## Eastern Harbour City

### Submissions Report

<b>Sydney Eastern City Planning Panel No.</b>	2017SCL040 RPA
<b>LGA</b>	Canada Bay LGA
<b>Proposal</b>	<p>The planning proposal seeks to:</p> <ul style="list-style-type: none"><li>• rezone land from IN1 General Industrial to R3 Medium Density Residential;</li><li>• increase the maximum permissible floor space ratio (FSR) from 1:1 to 1.6:1; and</li><li>• increase the maximum height of the building (HOB) from 12 metres to 25 metres.</li></ul> <p>The proposal will also identify the land as a 'Flood Planning Area' as per clause 6.8 of Canada Bay LEP 2013, and as an 'Intensive Urban Development Area' as per clauses 6.9 and 6.10 of Canada Bay LEP 2013.</p>
<b>Address</b>	7 Concord Avenue, Concord West Lot 1 DP 219742
<b>Applicant/Owner</b>	Elton Consulting
<b>Submissions</b>	<ul style="list-style-type: none"><li>• Public submissions (17)</li><li>• Public agency submissions (7)</li><li>• Submissions from Canada Bay Council (2)</li><li>• Submission from the Hon. Jodi McKay MP, State Member for Strathfield</li><li>• Proponent response to submissions (2)</li></ul>

Figure 7: Revised Master Plan Concept

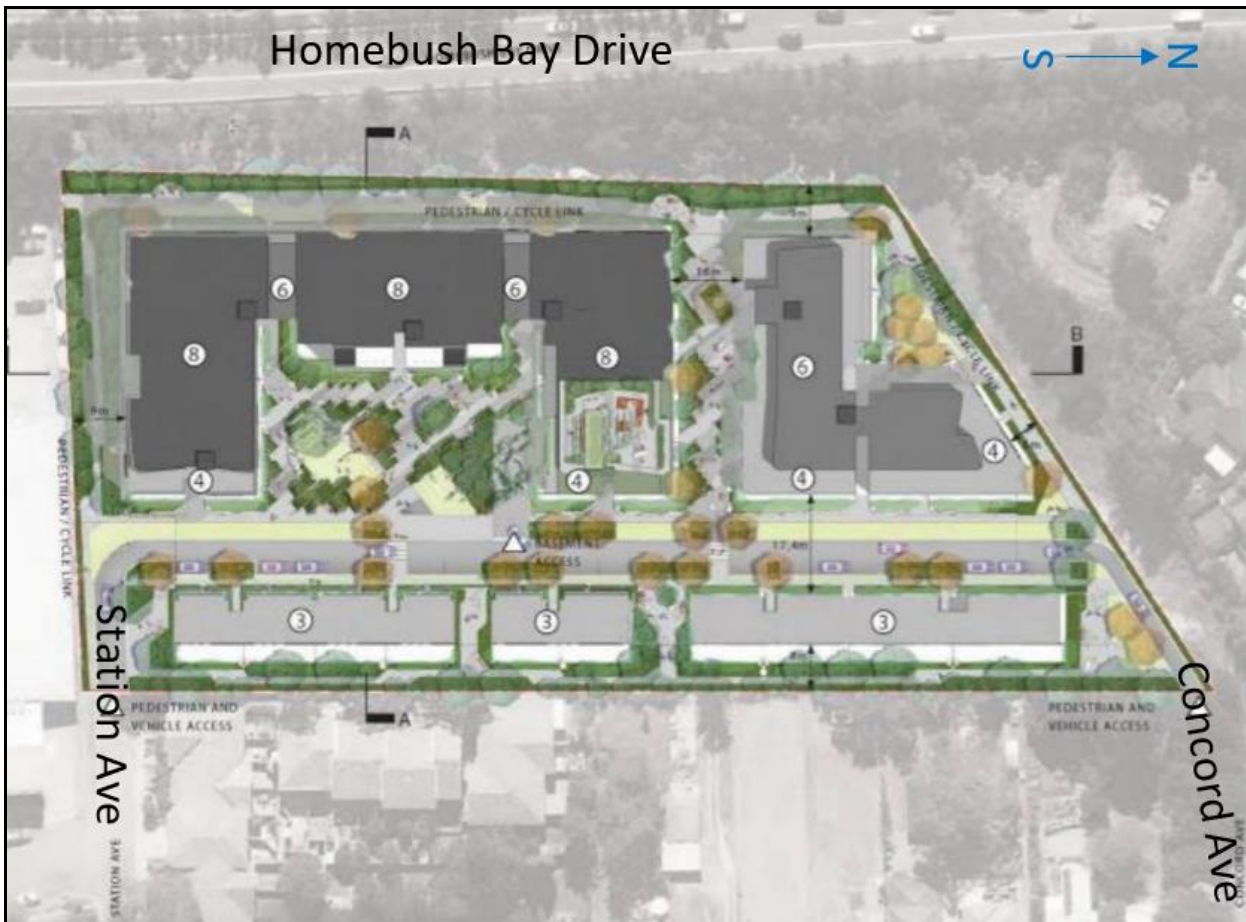
- the built form should be compatible with the surrounding heights and FSRs;
- an easement for drainage and Council stormwater pipe exists on the land that has not been adequately addressed in the planning proposal;
- the raising of land on the property has attributed to flooding to the rear of adjoining properties fronting King Street; and
- limited vehicular access is provided to the site from Station Ave.

**Figure 8:** Mitigation option supporting the exhibited plan (Elton, planning proposal 2018 -Source: Antoniades Architects and Catchment Simulation Solutions 2018)

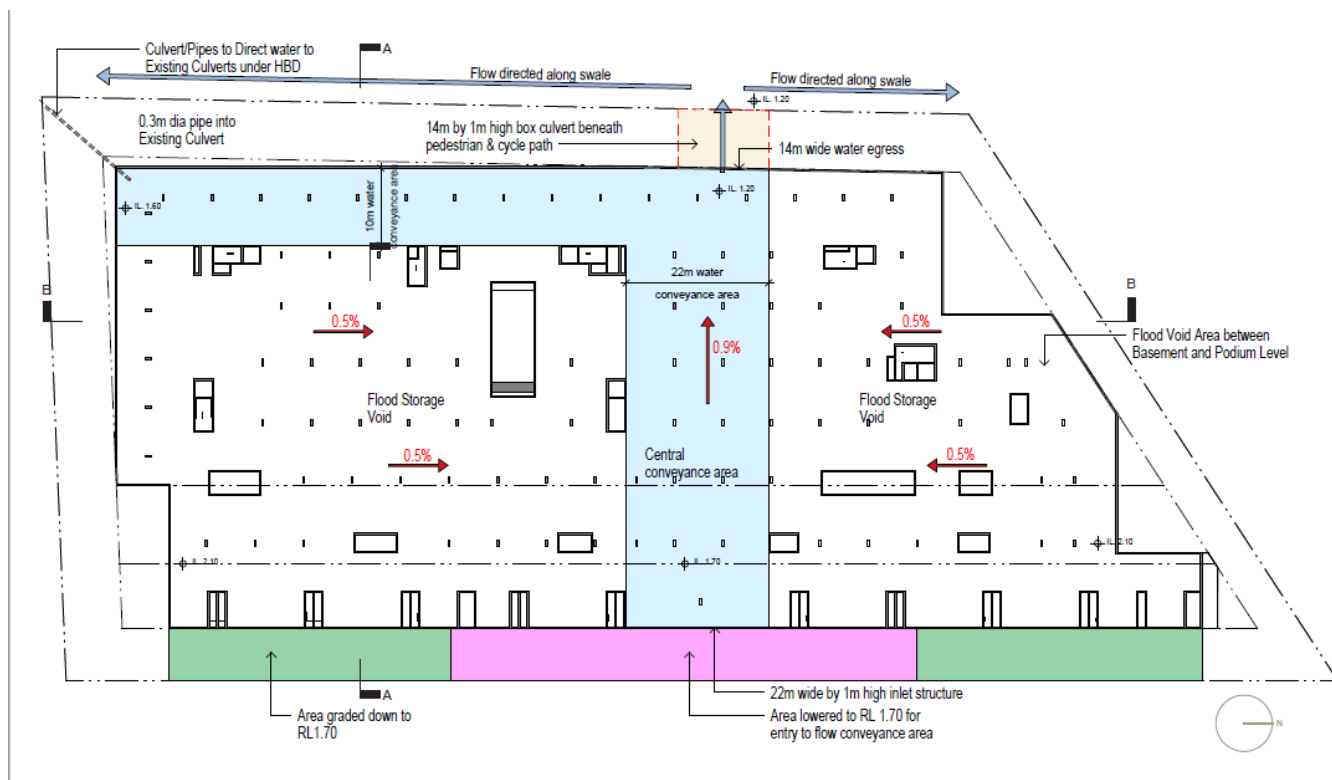
The flood assessment by Hydro Spatial (2018) estimates that the site is affected by depths of approximately 0.8 m in the 1% Annual Exceedance Probability (AEP) event and 2.4 m in the PMF event. In summary the assessment considers that in any given year the 1% AEP event has a 1% chance of occurring, or a 55.25% chance of occurring over an 80-year time frame. It is a reasonable expectation that a flood of this magnitude will occur over a lifetime. However, it is very unlikely that a flood with the magnitude of a PMF will occur over a lifetime. The proposal is discussed in more detail later in the report under key issues – 4.1 Flooding.

It also advises that the assessment demonstrates suitable mitigation solutions and demonstrates that potential flood impacts can be appropriately mitigated. However, OEH does recommend that the Flood Emergency Response Plan provide additional flood signage detail indicating evacuation routes and a review of mitigation options in the PMF event (**Attachment H**).

- Whilst the proposal does indicate a shelter in place response, the flood risk assessment found that due to the flash flood nature of the catchment, there would be negligible opportunity for vehicular escape from the site prior to or during the flood. Accordingly, emergency services are still featured in the plan and therefore will be required to assist should flooding occur.
